Premstätten, January 22, 2020

Process Change Notification PCN 03-2020

This PCN covers the process change at ASE CL Taiwan and will be implemented on TMF8701 and TMF8801 products.

Figure 2. The product level validation that will be performed thru reliability testing.

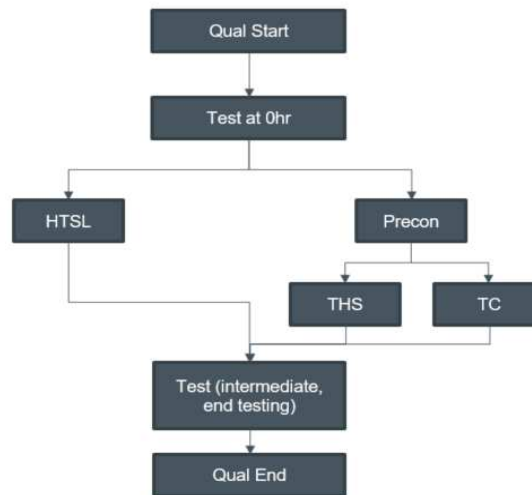
A product level validation through reliability testing is ongoing.
Final report will be provided once completed.

Accelerated Stress Test	Industry Standard	Condition	Sample Size
High-Temperature Storage Life Test (HTSL)	JESD22-A103	500h, 85°C	1 lot / 77 samples
Preconditioning (PC)	J-STD-020	Depending on the package technology (MSLx). This is a requirement before doing TC and THB	1 lot / 77 samples
Temperature Cycling (TC)	JESD22-A104	500c, -40°C/85°C	1 lot / 77 samples
Temperature Humidity Stress (THS)	JESD22-A101	500h, 85%RH/85 °C	1 lot / 77 samples
